**ADDENDUM NO. 2
TO CONTRACT DOCUMENT PLANS SPECIFICATIONS**

**PROJECT: MWA METRO PARK WEST LANDFILL
P-67 CELL E LINER, LEACHATE LAGOON, AND SED POND**
TO: PROSPECTIVE BIDDERS AND OTHER INTERESTED PARTIES

SHEET G002

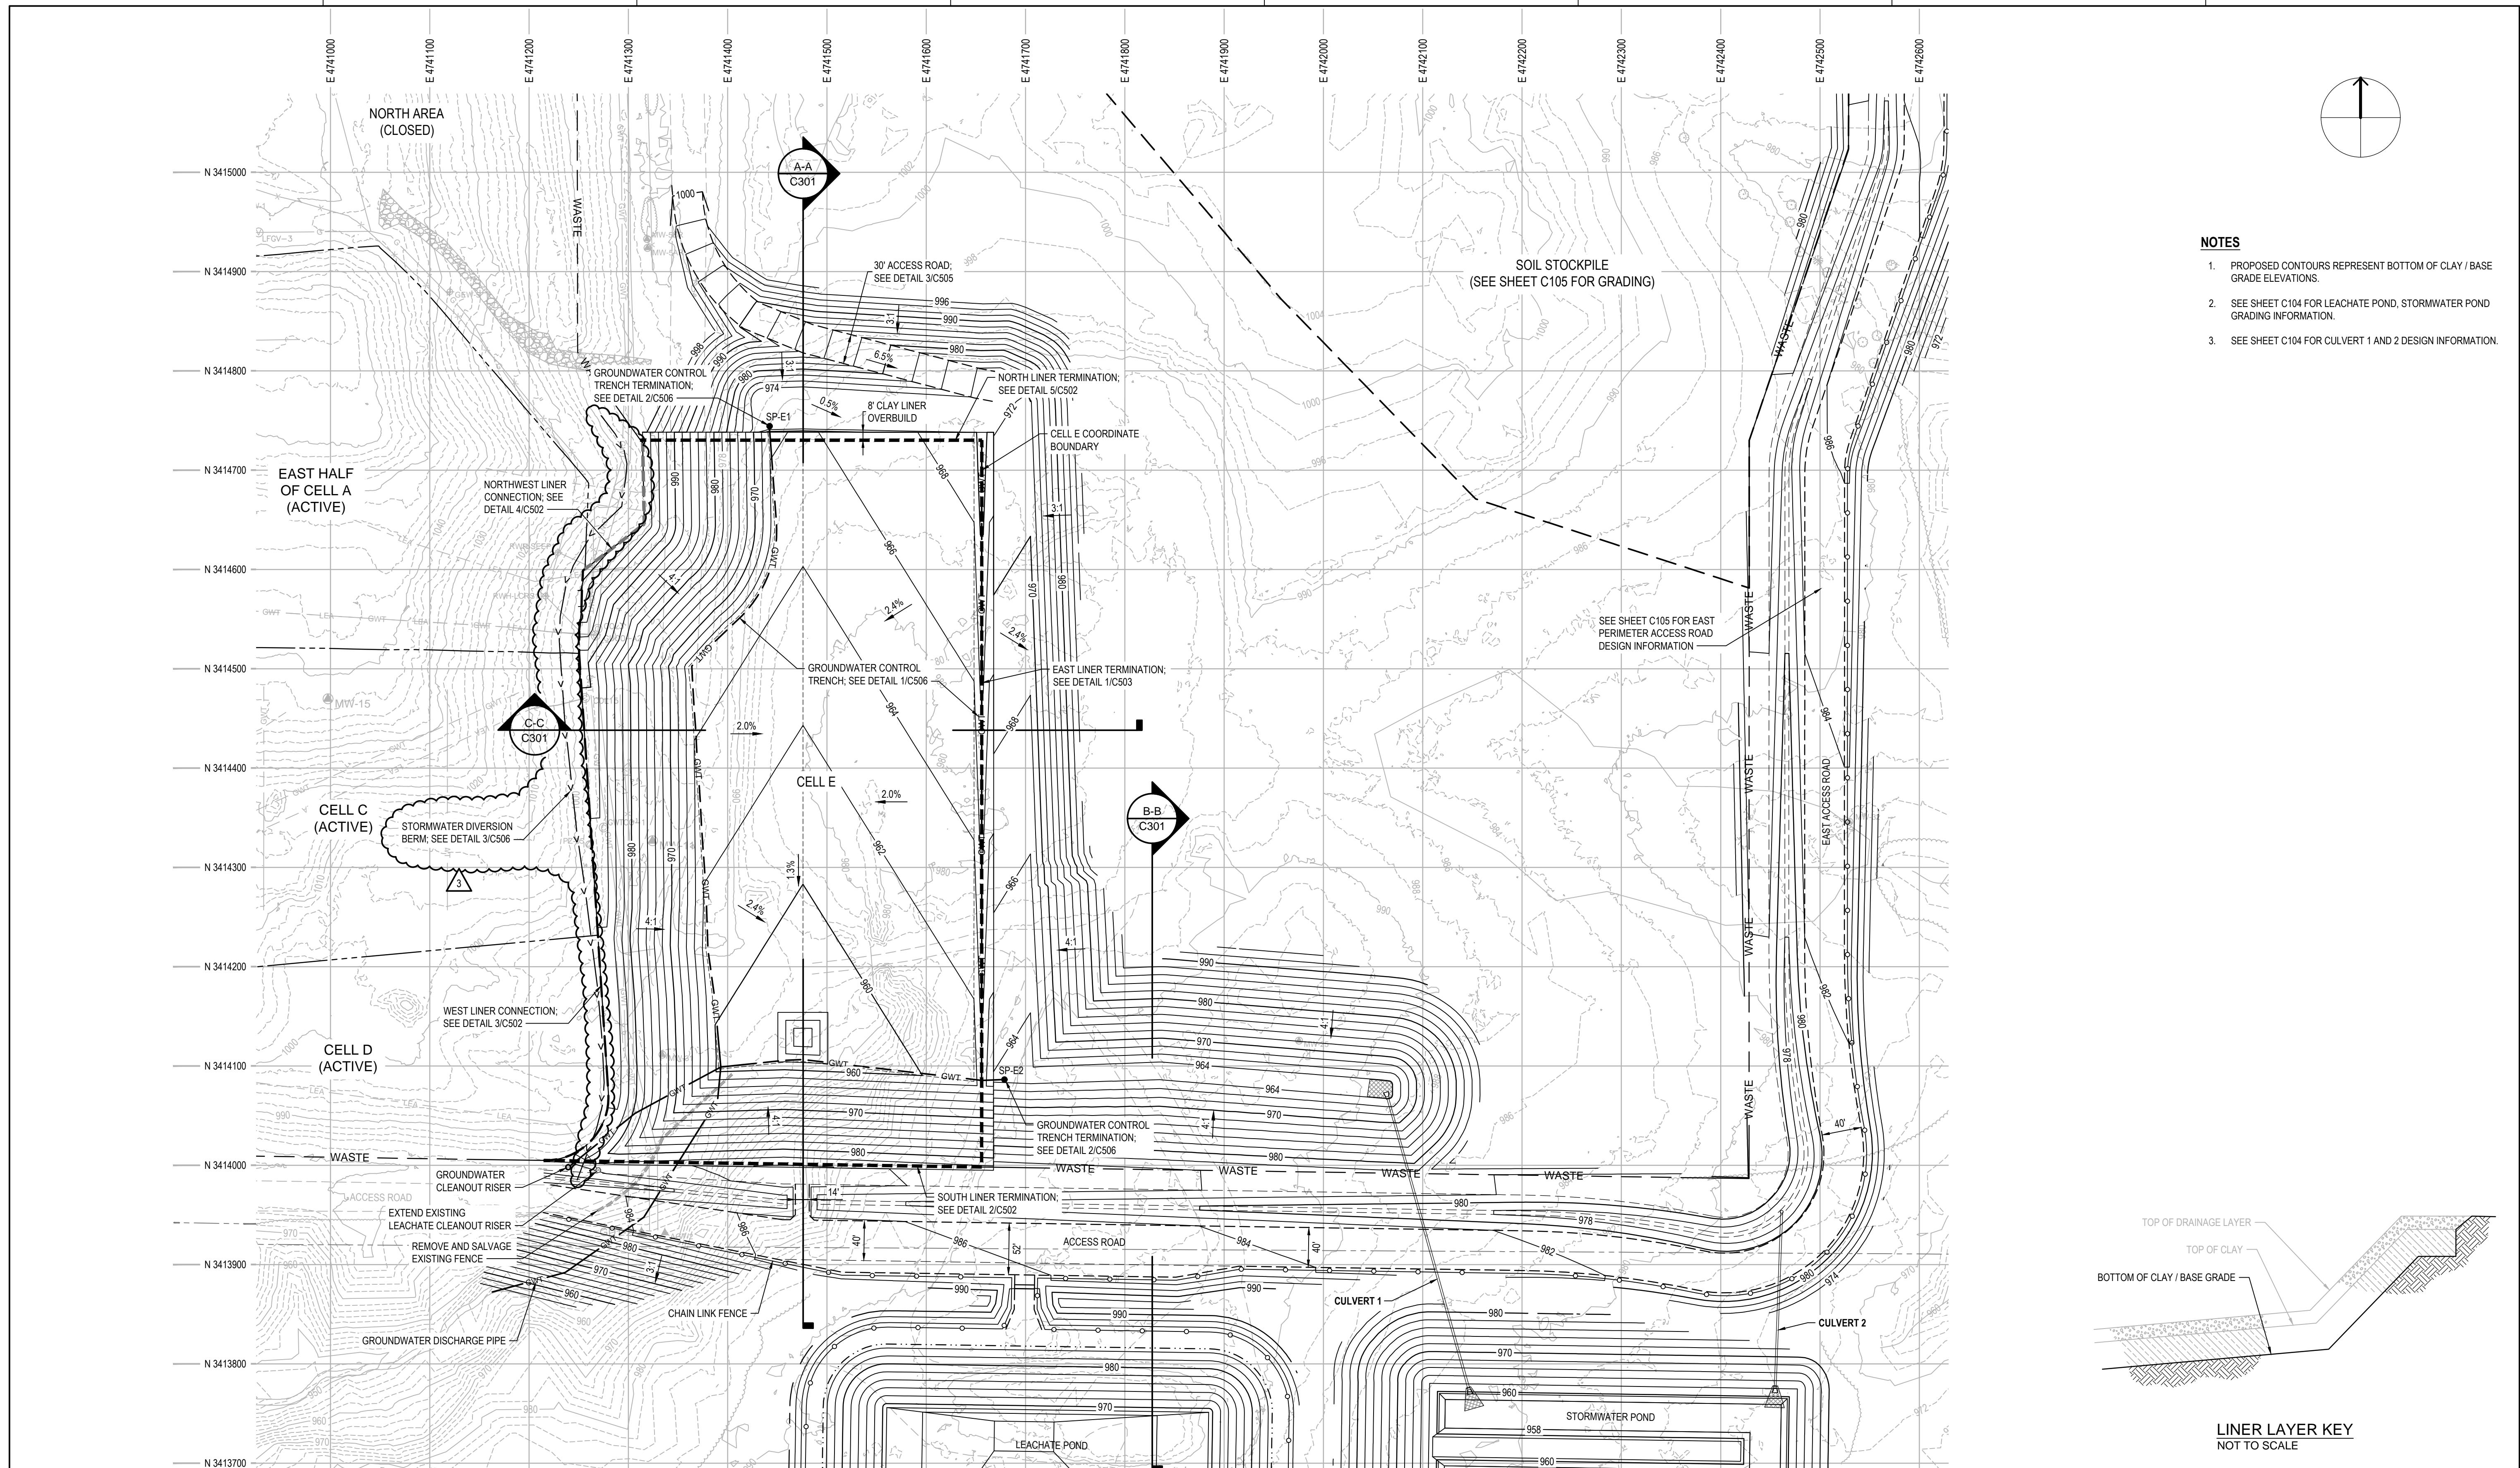
Question 16: The scale on Sheet G002 doesn't appear to be correct. The grid is 200' x 200' and based on that, the scale is 1"=150'. Can you please confirm?

Answer 16: Scale on Sheet G002 has been revised to 1" = 150'.

EAST PERIMETER ROAD GRADING AND DEVELOPMENT PLAN

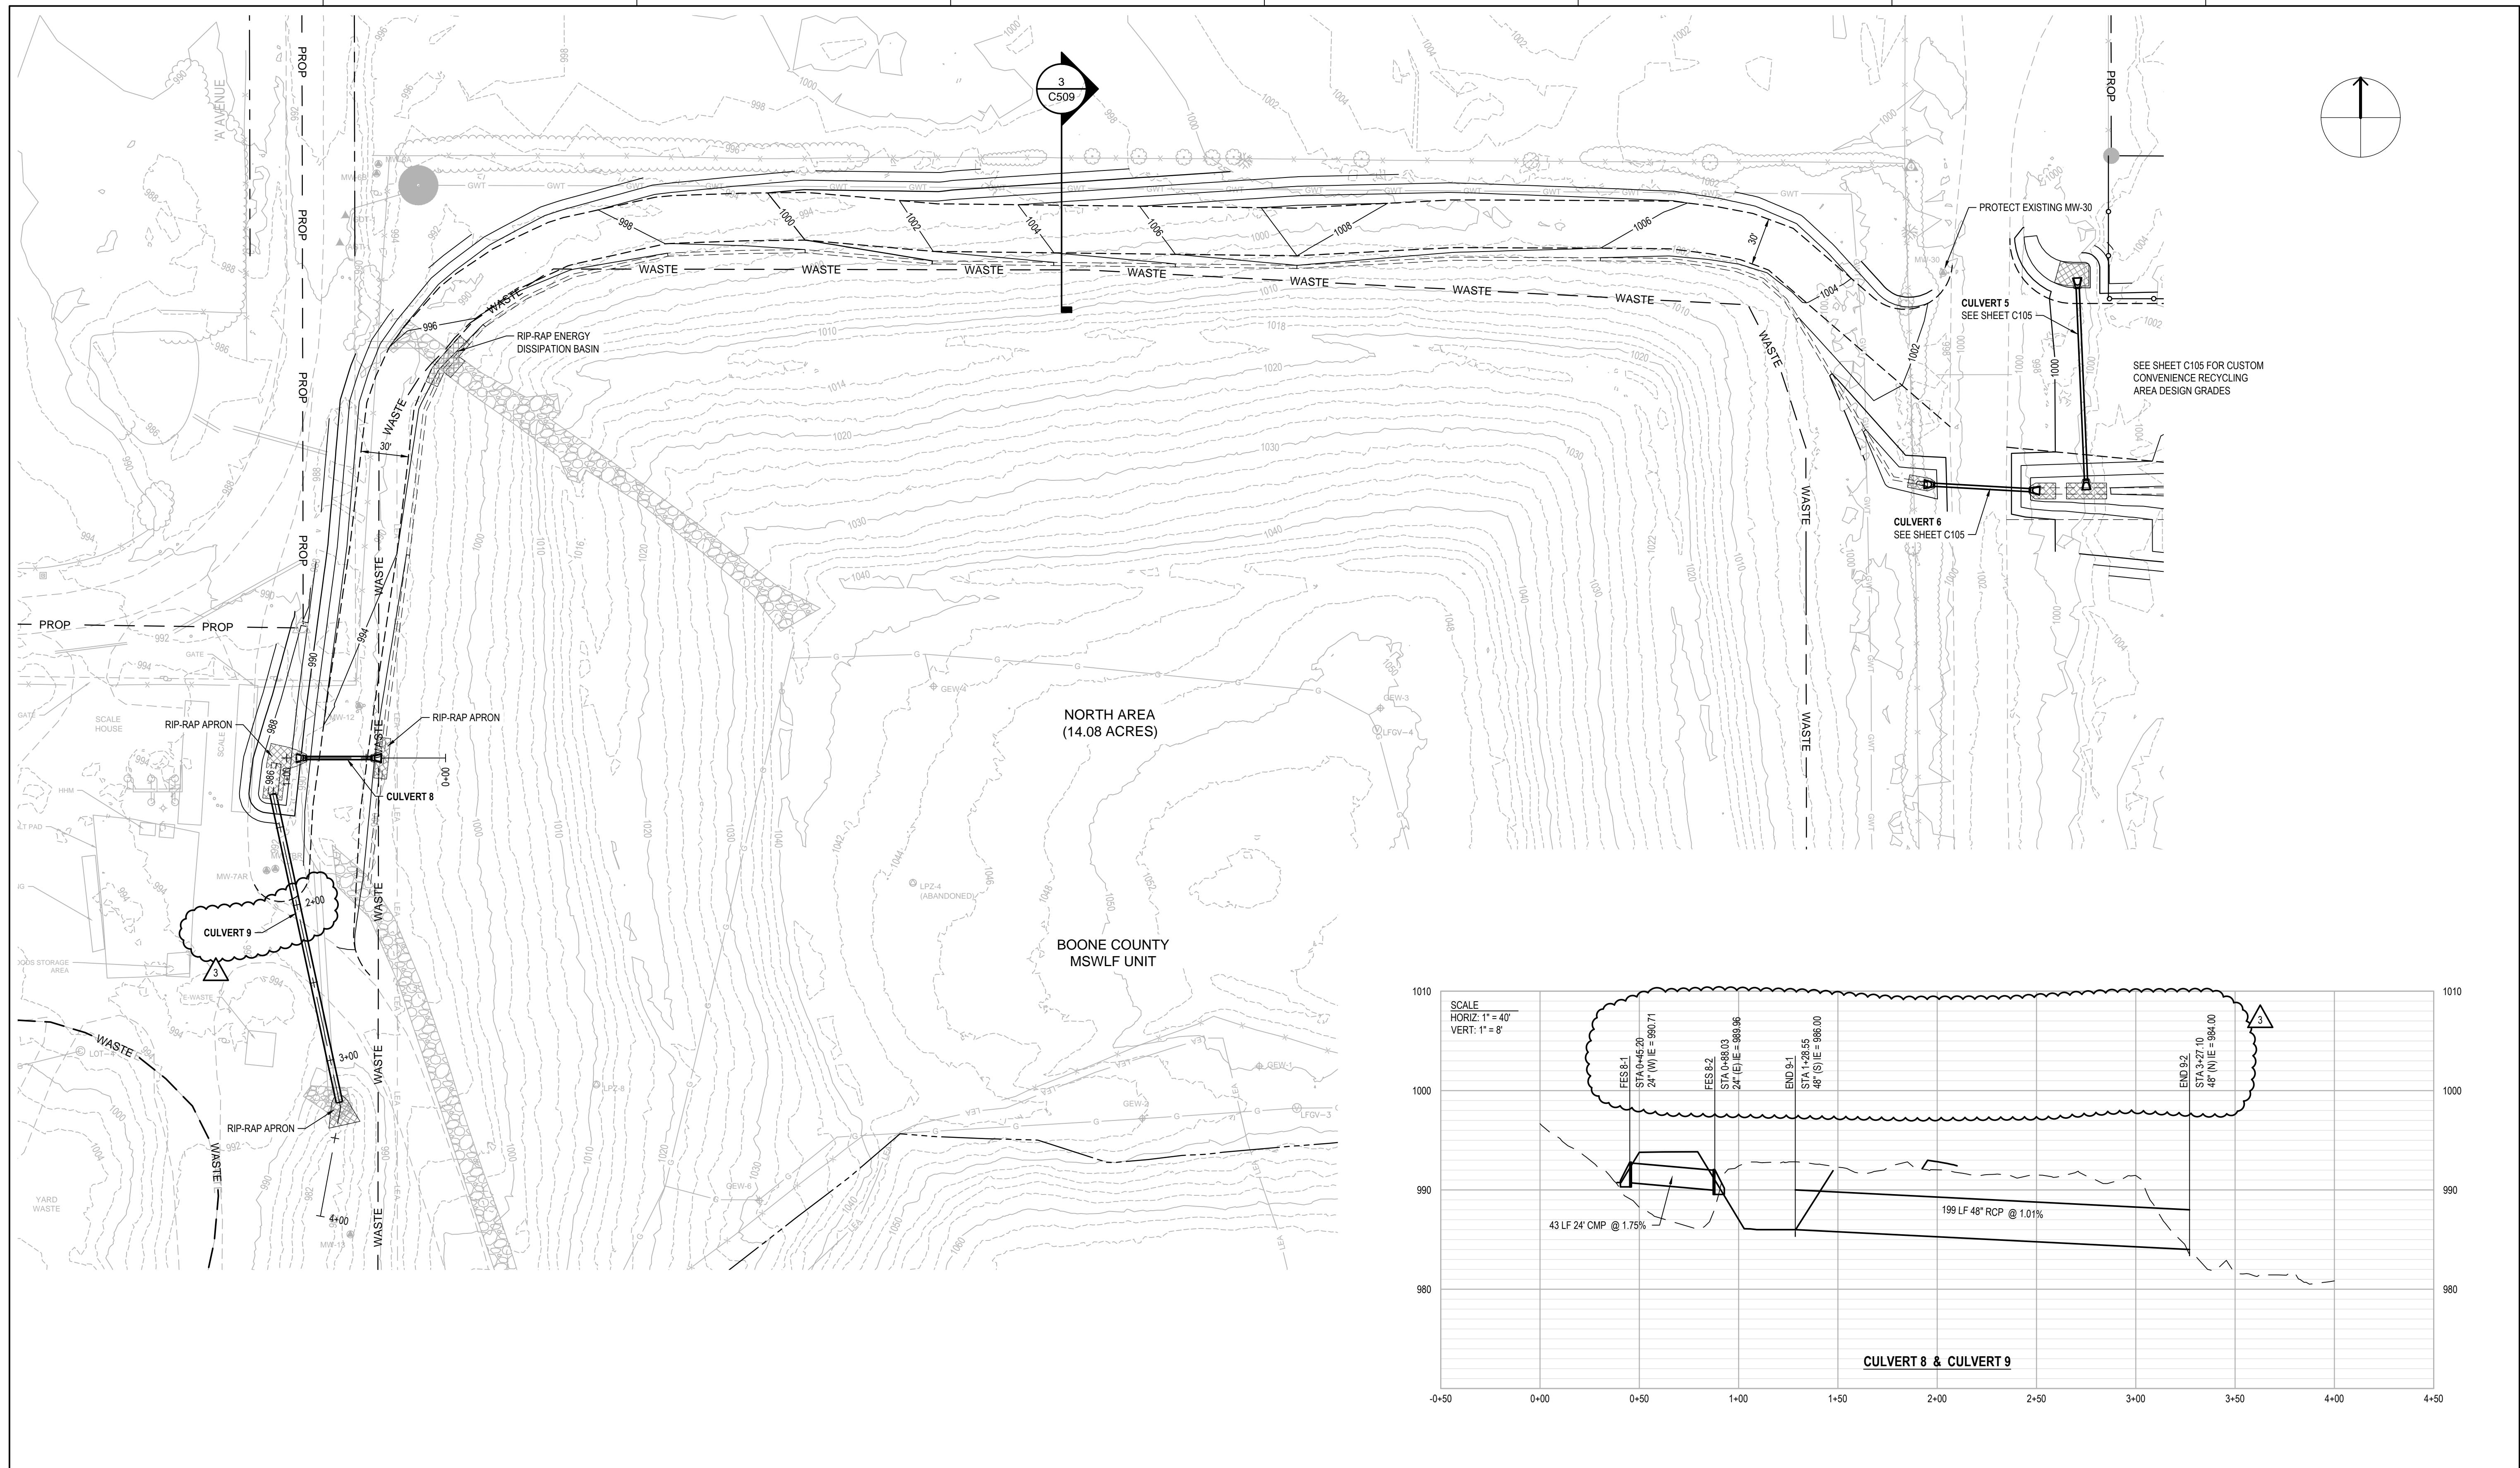
Question 6: *Can you please provide additions details to the Z-Wall guardrail detail to include material type (kind of aluminum, wall thickness, etc...), diameter of pipe, dimension for the center rail, etc.?*

Answer 6: The guardrail portion of the Z-wall has been replaced with concrete. Please see Sheet C105 and Sheet C510 for updated Z-wall design.

SHEET: C504

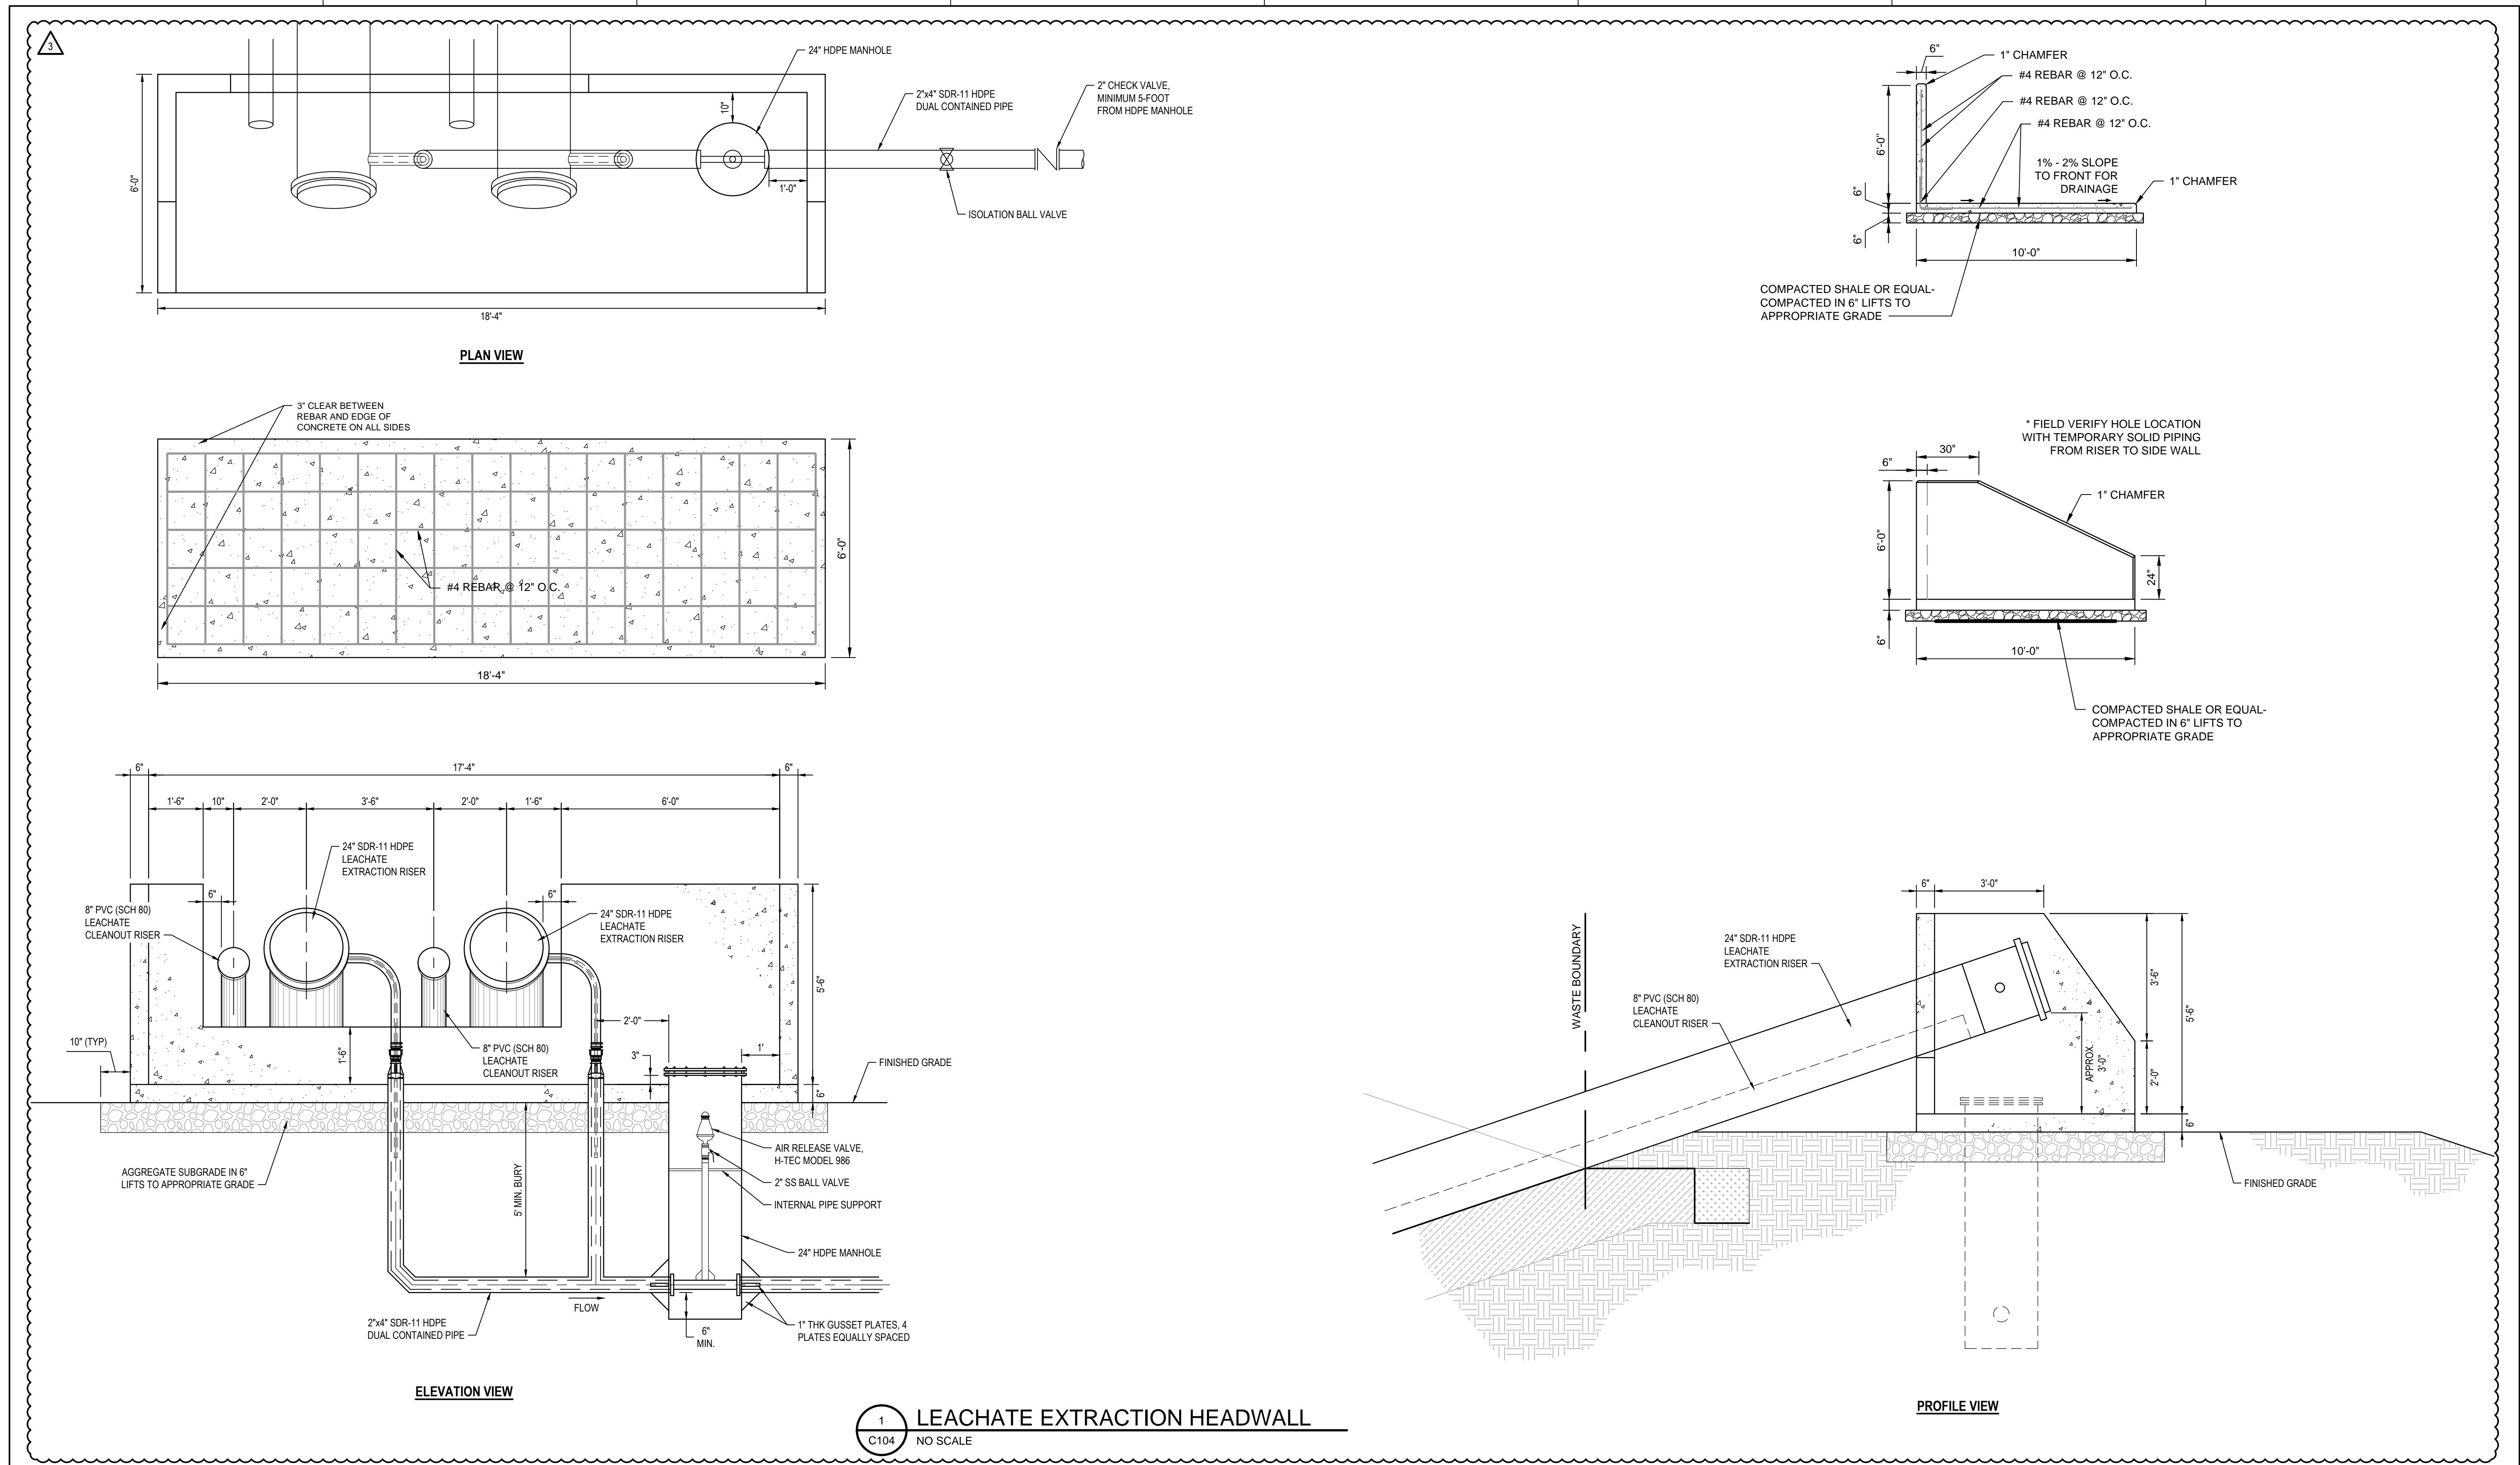
Question 32: It looks like there is a "Leachate Transducer Riser" on sheet C103 but it is not present in the detail – Please let me know what material you would like here and provide detail.

Question 37: Sheet C504, Detail 2, Can you clarify the dimensions required for the sheet stock at the bottom of the sump?

Answer 32: Please see updated Leachate Collection Sump detail on sheet C504. Leachate Transducer riser will be 8" PVC (SCH 80) Perforated pipe.

Answer 37: Flat stock removed from sump detail.
